Subject: Engineering, Procurement and Construction (EPC) Contract for Renovation and Modernization of Existing Navigational Lock at Farakka, West Bengal.

Reference: IN-IWAI-350002-CW-RFB-2

CPP Portal Tender no: 2023_JMVP_782597_1

JOB. NO. DRG. NO.
ENL012

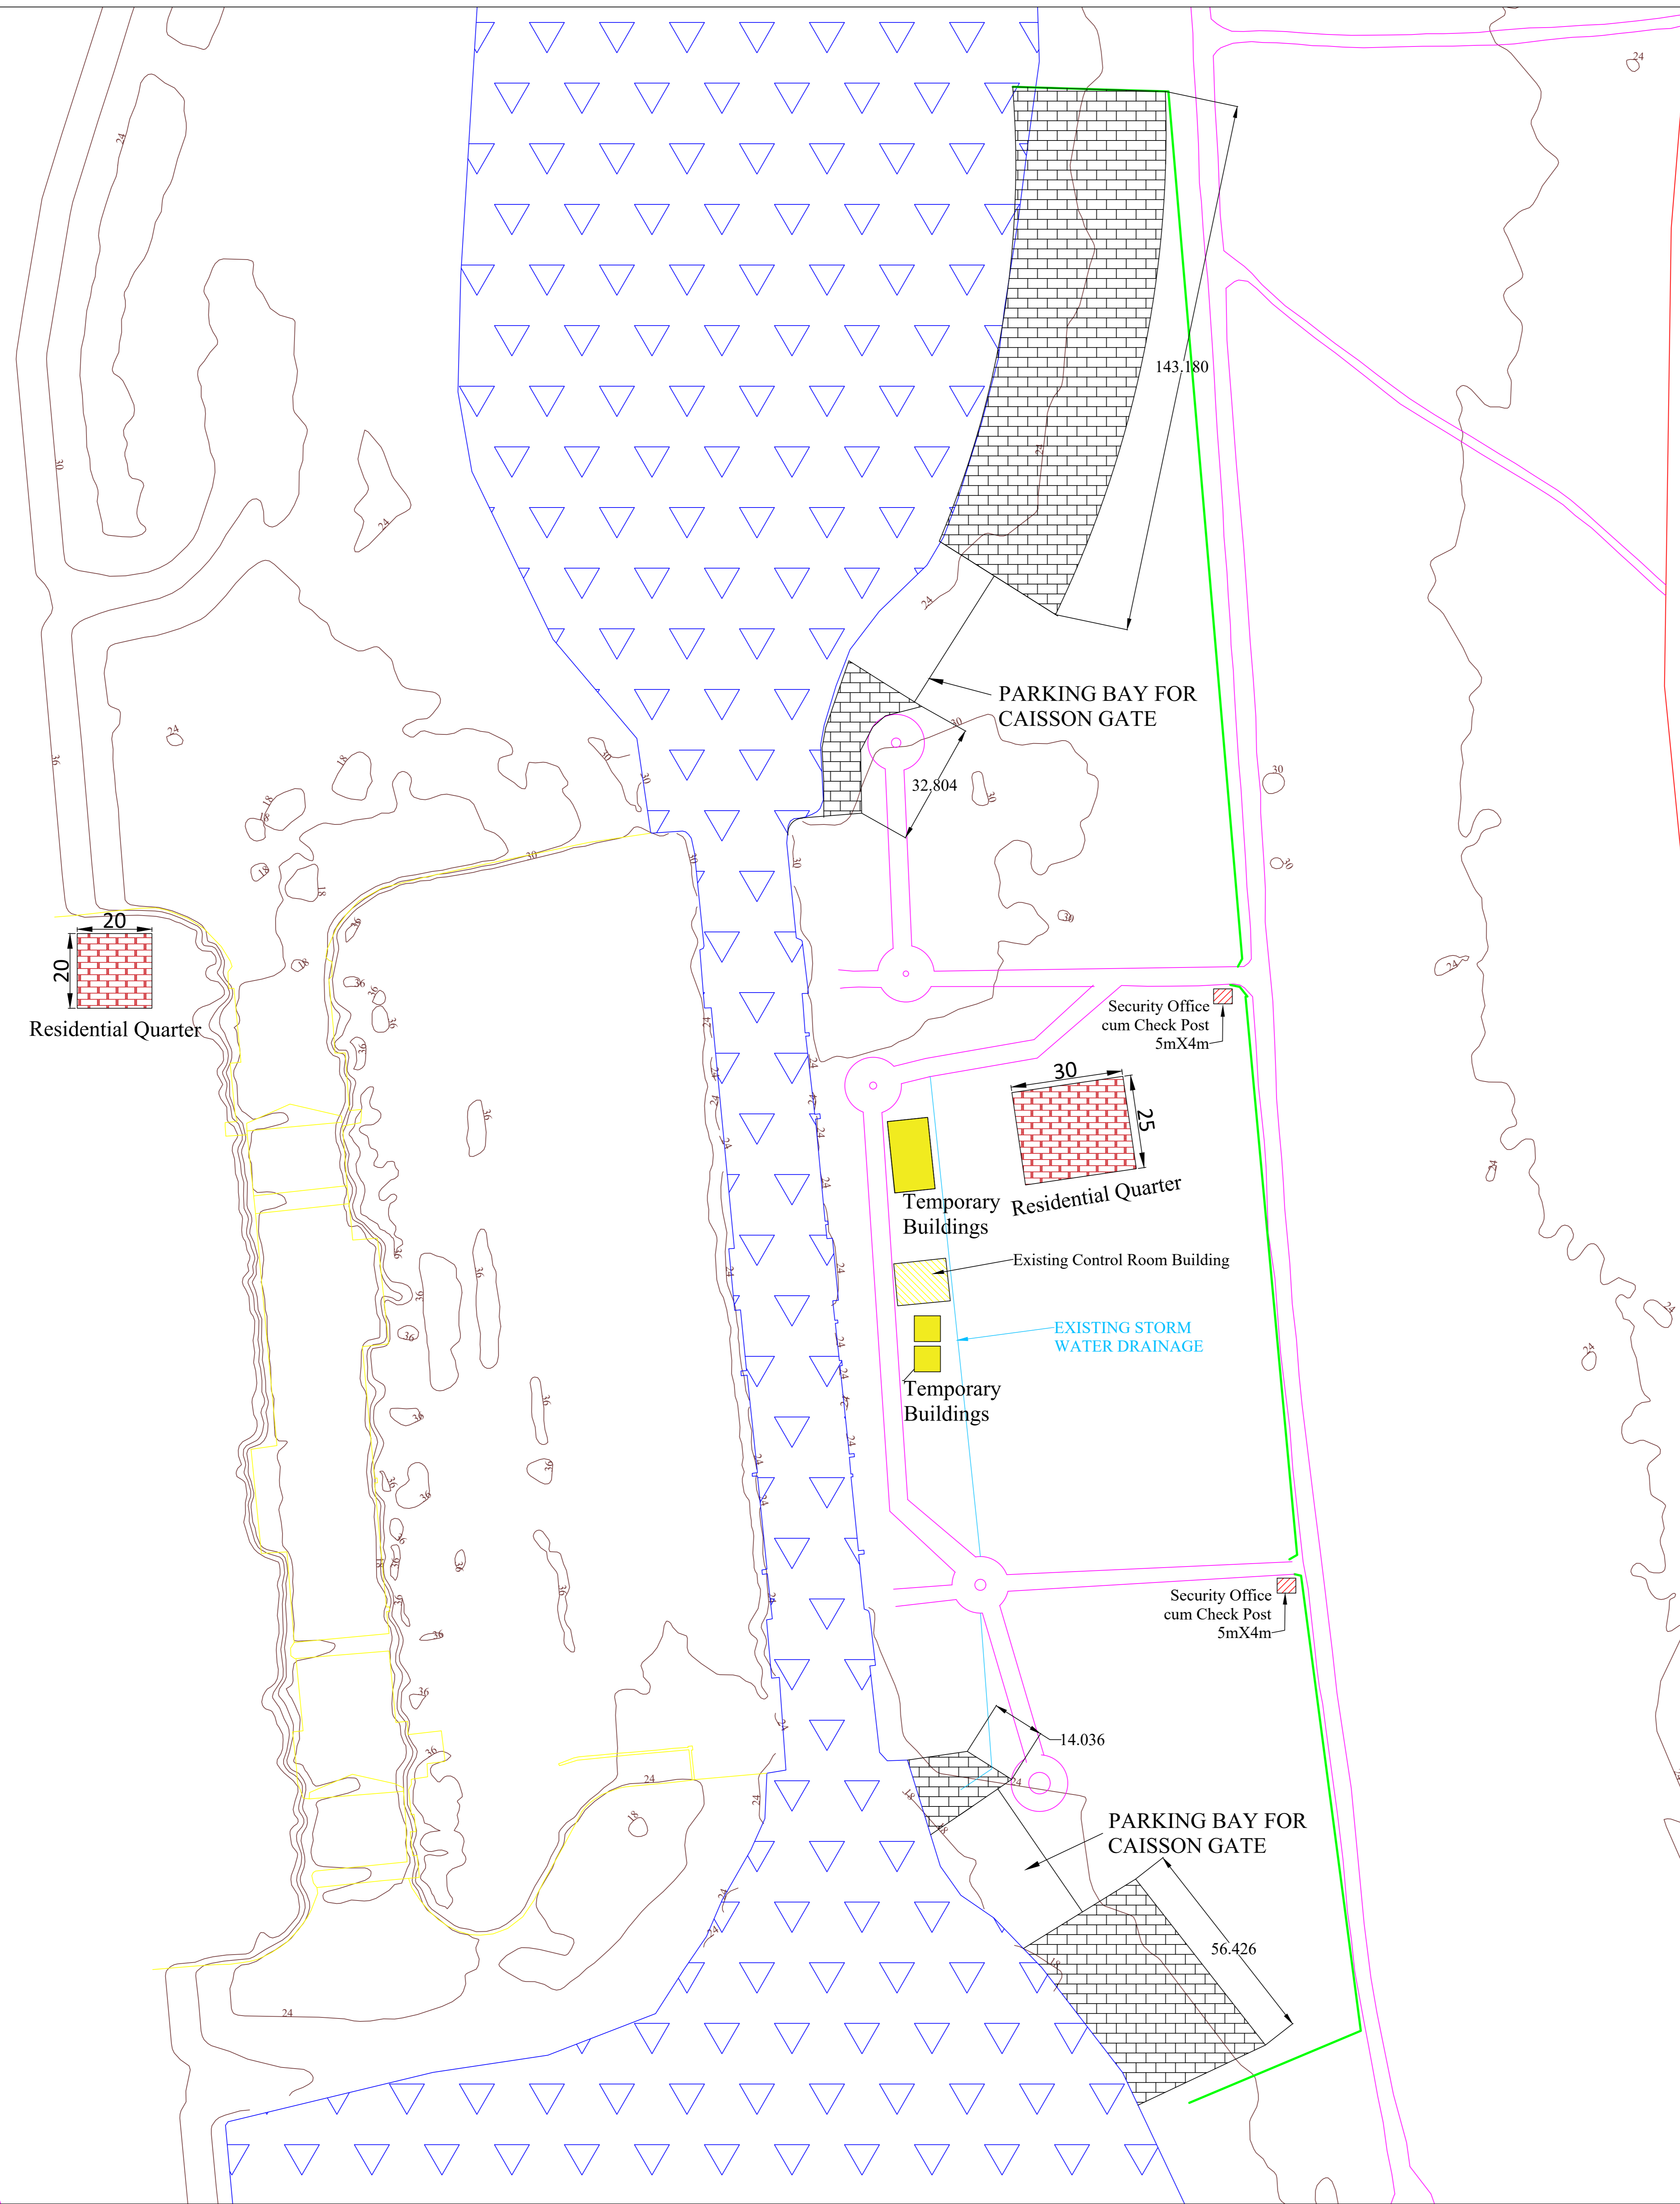
72	"BASIC CONTROL SYSTEM ARCHITECTUR E OF EXISTING LOCK, FARAKKA	CCTV system	As per tender drawing, CCTV cameras are connected with Ethernet switch of Main PLC. As per OEM architecture of CCTV system, CCTV cameras will be connected with CCTV rack/panel from which the CCTV workstation will be	Tender conditions prevail. As per drawing, it is a standalone system. Appropriate CCTV system shall be designed & establish at the Existing Navigation Lock control room.

(DRG. No: ENL012)" CONTROL SYSTEM		communicated. hence we are clarifying that CCTV system will be standalone system. We are proceeding as per above said clarification. Kindly provide your confirmation.	
73	"GENERAL LOCATION PLAN FOR MONITORING INSTRUMENTATION OF EXISTING NAVIGATION LOCK, FARAKKA (DRG. No: ENL014)" "MONITORING INSTRUMENTATION"	Monitoring Instruments	As per tender drawing, Monitoring field instruments are proposed for both locks (existing and new lock structure). However, There are field instruments were already provided on single side (east bank) of new lock and single side (west bank) of existing lock during construction of new lock. Hence, Those instruments will be used for monitoring, and new instruments will be considered only for existing lock (east bank).	Tender conditions prevail.
74	Electrical "Clause: 1.2.12.2 Detailed Electrical Scope of Work" pg 33 of 571	WBSEDCL Metering Panel location	As per specification, we understood that the metering panel will be supplied by WBSEDCL. Kindly confirm the location of metering panel.	Location shall be decided as per the guidelines/ in consultation with WBSEDCL. Tender conditions prevail.

JOB. NO.	DRG. NO.
	ENL013

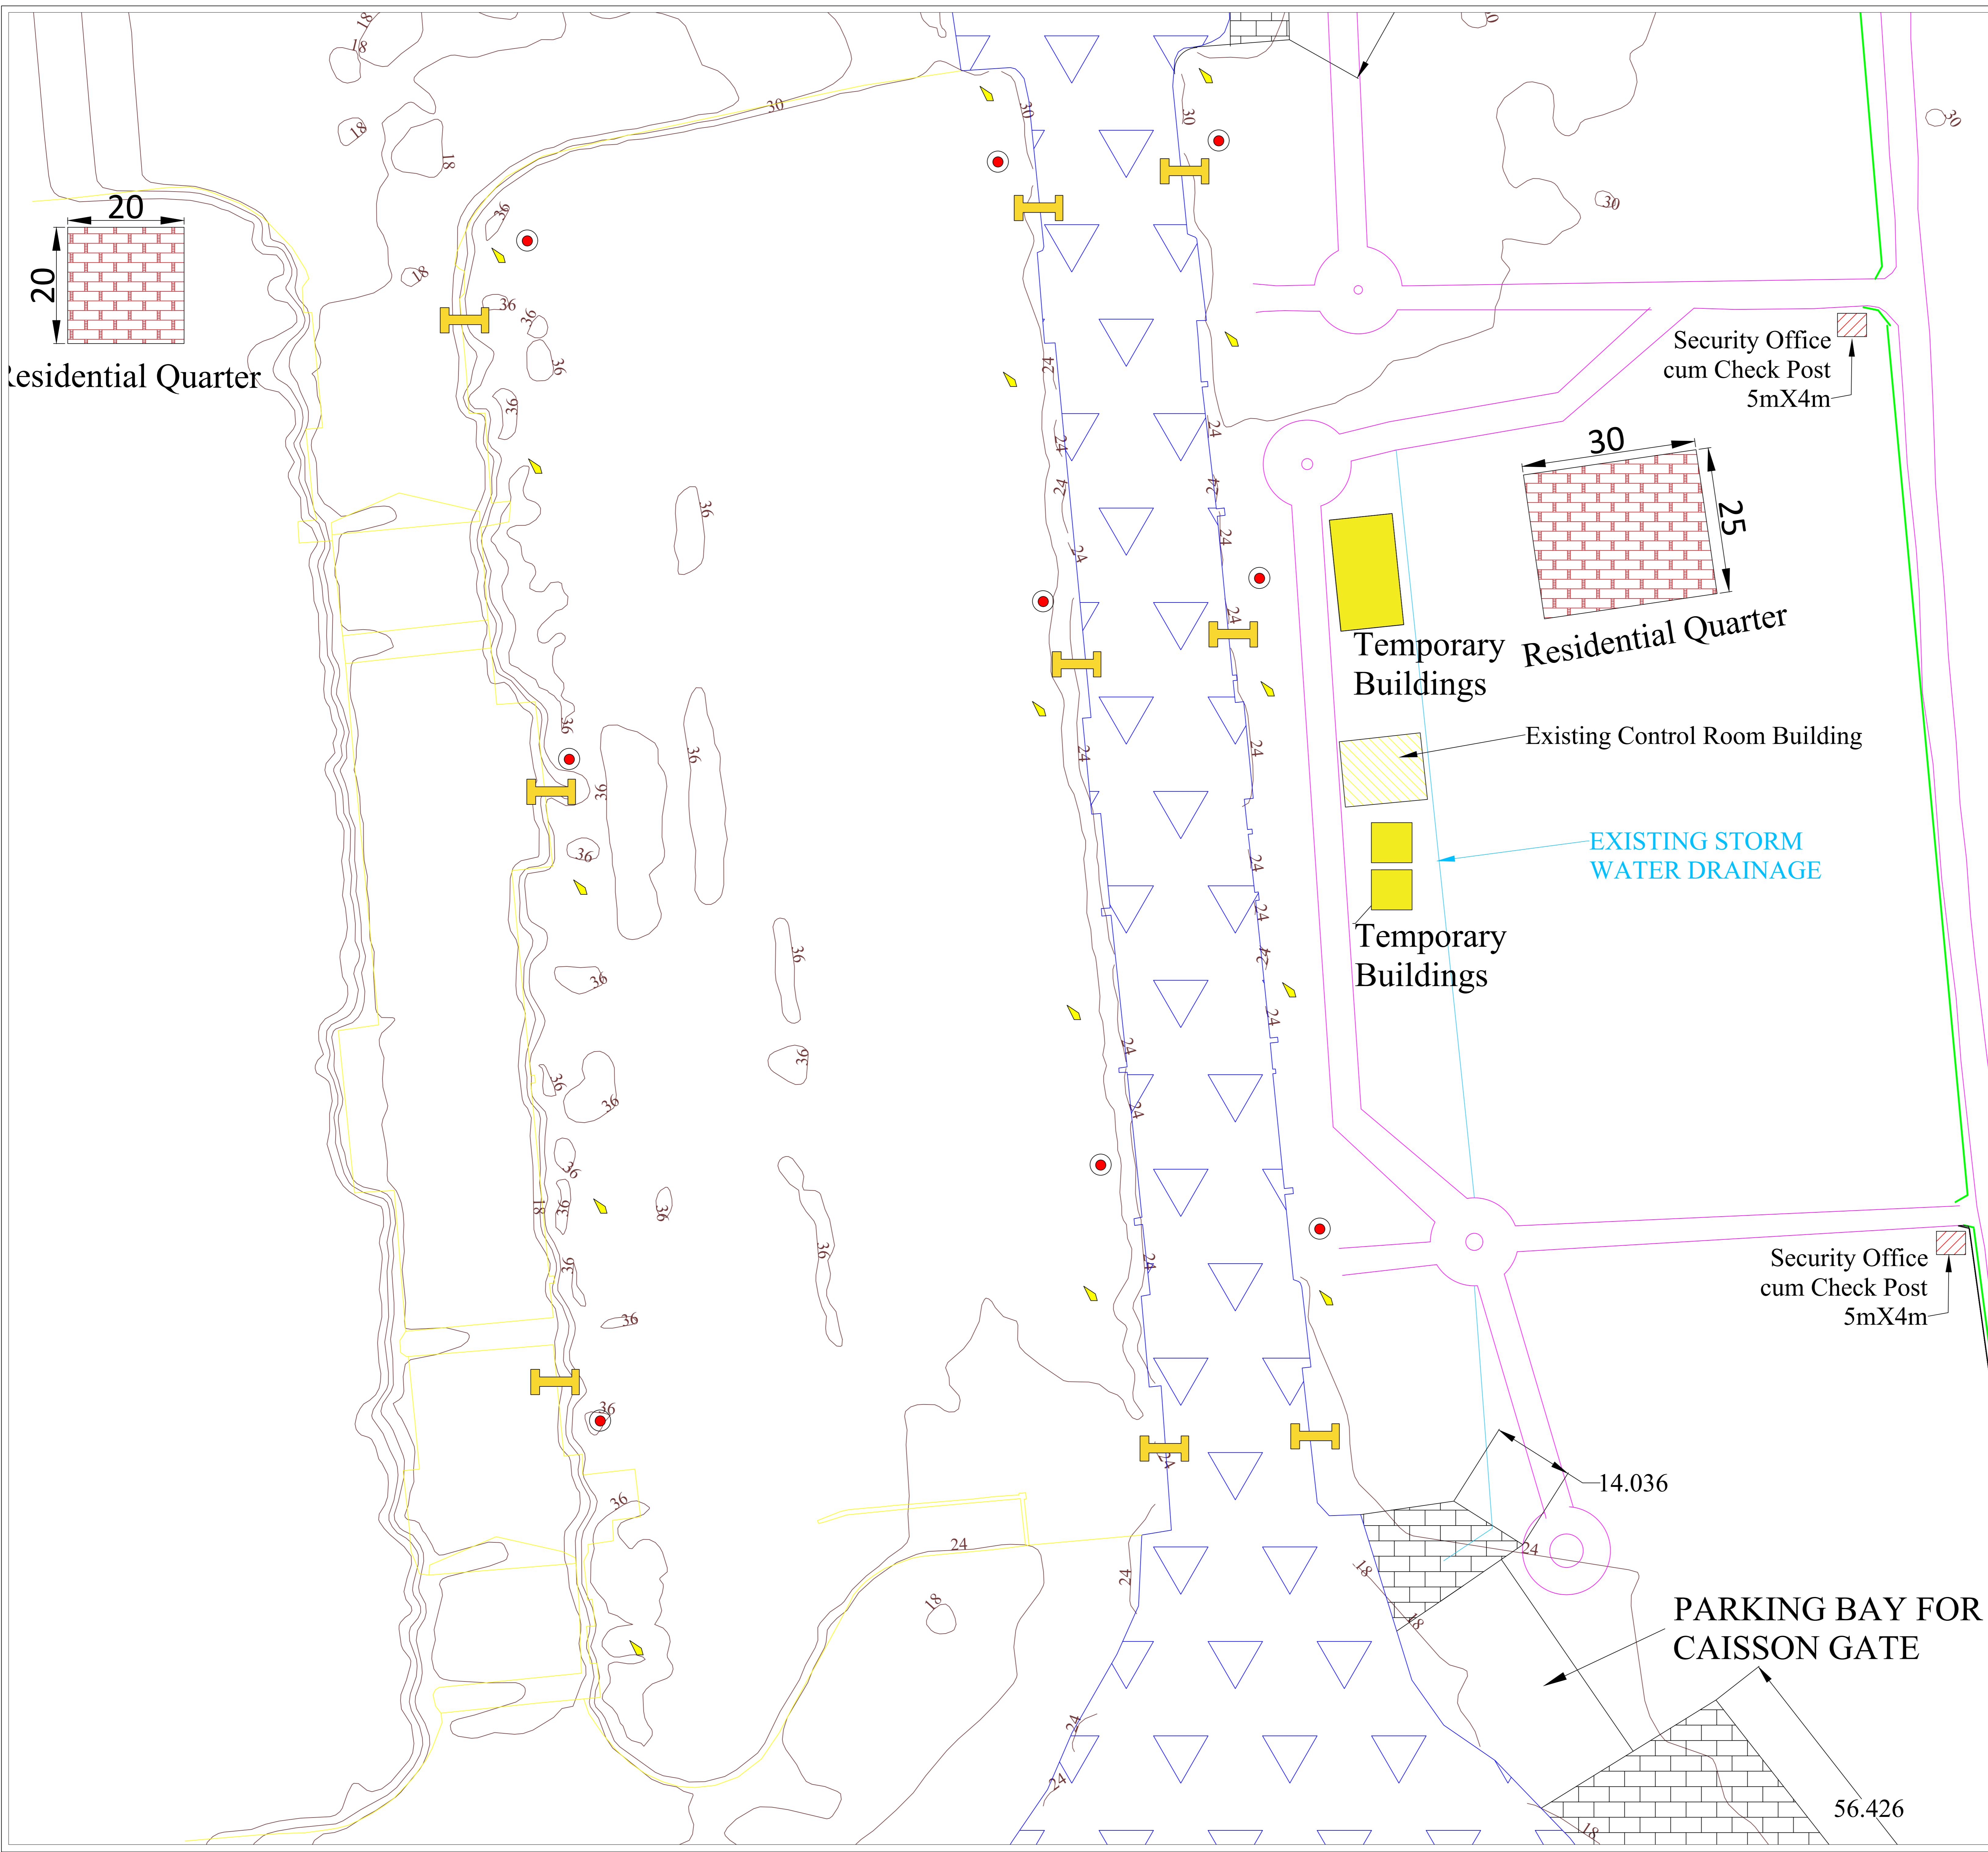
35	Volume 2:Civil Structural 1.2.2, Page No- 26	Renovation/Modernization of lock structure including all associated facilities	Please clarify the method to Renovate/Modernize the lock structure	Tender conditions prevail.
36	Volume 2:Civil Structural, 1.2.5.1, Page No- 28	The Contractor shall renovate / modernize the existing control room at central place of existing Navigation lock for remote control operation of gates of lock	<ol style="list-style-type: none"> 1. Please clarify the Additional requirements like lifts, Emergency staircase, firefighting arrangements etc., 2. Confirm the Location of the Main Control room 3. Whether any Local control rooms to be constructed please clarify. 4. Please clarify the Specifications & scope of works for the Renovation required 	<p>There is no additional requirement. Safety certificate from concerned authority shall be obtained by the EPC Contractor at his own cost. This may require lift, fire & other safety aspects as per NBC.</p> <p>Please refer drawing no ENL013_R1 for location of main control room.</p>

shall be granted by Employer on request of bidder.	
108	Residential Buildings, Vol II, 1.2.5.2, Page No- 29	Location of the proposed quarters are shown in Drawing No. ENL 013	It is requested to consider the location of residential buildings on left side of Lock chamber beside existing control room or at locations as decided by Engineer-in - charge as per site conditions to maintain aesthetic aspect in between two Navigation Locks.	Please refer drawing number ENL 013_R1 attached at Annexure-A.
109	Synchronized Operation of Existing and New Navigational Lock through Integrated Signal System, Vol II, 1.2.16, Page no- 41	The movement of traffic through both the navigational locks (Existing & New) shall be managed from an integrated signal system. The integrated signal system should be installed at the upstream and downstream of the lock for synchronized operation through both the locks (Existing & New) resulting in safe and reliable and smooth movement of vessels. The integrated signal system should be interoperable from both the existing and new navigational lock control room . The Contractor shall do the design, installation, testing and commissioning of the integrated signal system for traffic management for synchronized operations of the movement of traffic through the Existing and New Navigational lock as per specifications for Signal System	It is submitted that guarantee and performance of New Lock signal system, after integration of system by bidder, shall lie with the Employer only.	The guarantee & performance of new navigational lock signal system is not in the scope of the subject contract. However, the signal system shall be synchronized by the Contractor under this contract. Clause no 1.2.16 at Page no- 41, Vol-2 may be read as: The movement of traffic through both the navigational locks (Existing & New) shall be managed from an integrated signal & Hooter system. The integrated signal & Hooter system should be installed at the upstream and downstream of the lock for synchronized operation through both the locks (Existing & New) resulting in safe and reliable and smooth movement of vessels. The integrated signal system should be interoperable from both the existing and new navigational lock control
